December 20, 1978

SUBJECT: NYSE&G 1 and 2 (P-657)
Draft Future Amendments for PSAR Chapter 7

DRAFT CHAPTER 7

FIGURE 7.1-1

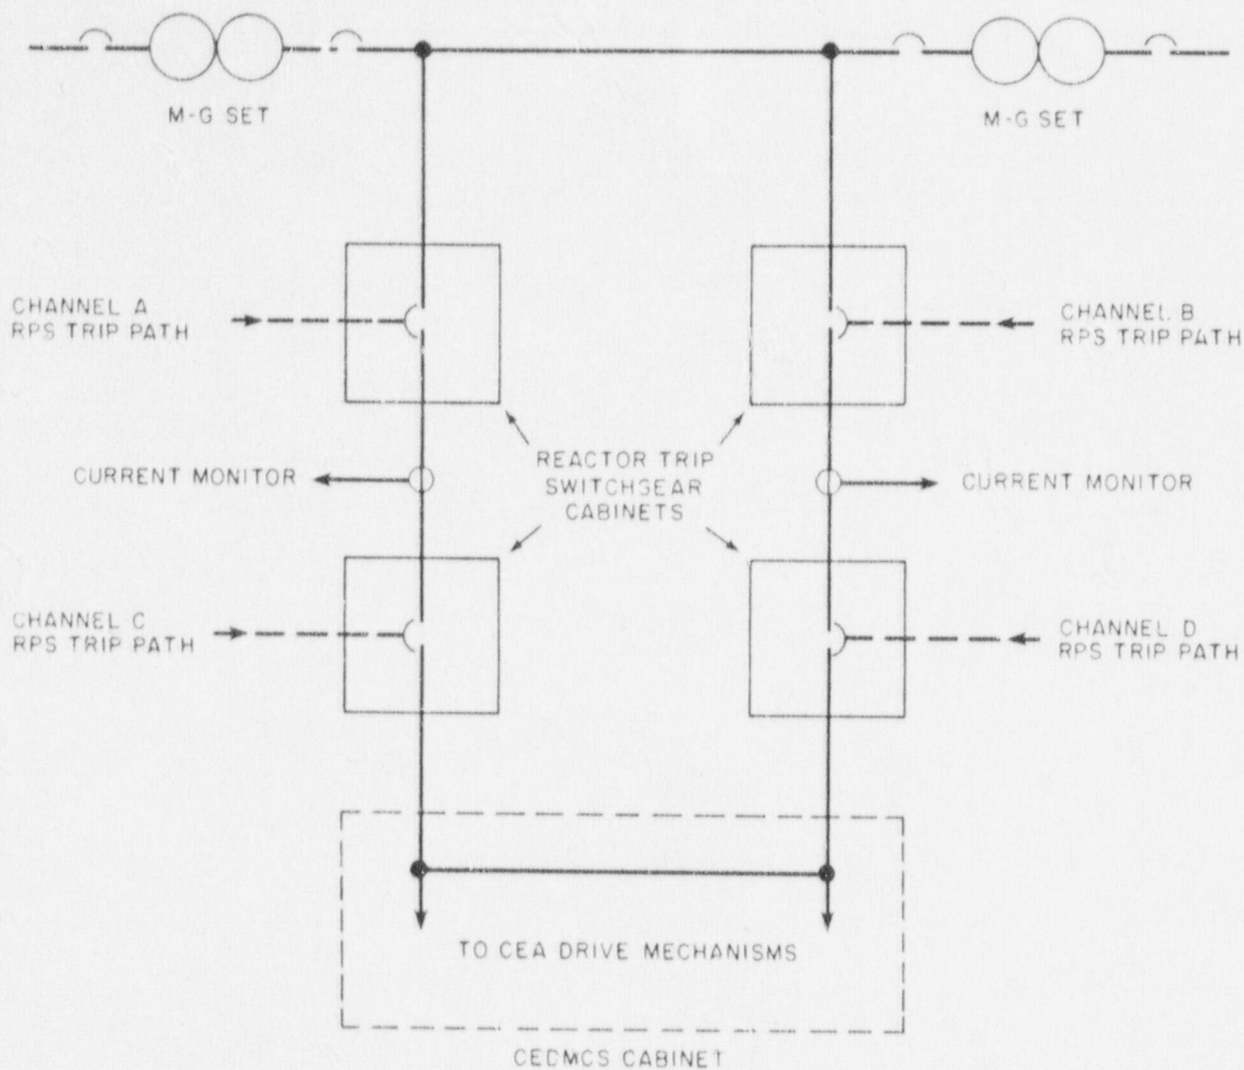
- 2) The Reactor Trip Switchgear, as defined in the Yellow Creek Nuclear Plant Preliminary Safety Analysis Report, consists of a single enclosure containing nine trip circuit breakers. The NYSE&G design includes four separate enclosures for the trip circuit breakers; circuit breaker configuration and bus work have been modified for compatibility with the repackaging as shown in Figure 7.1-1.
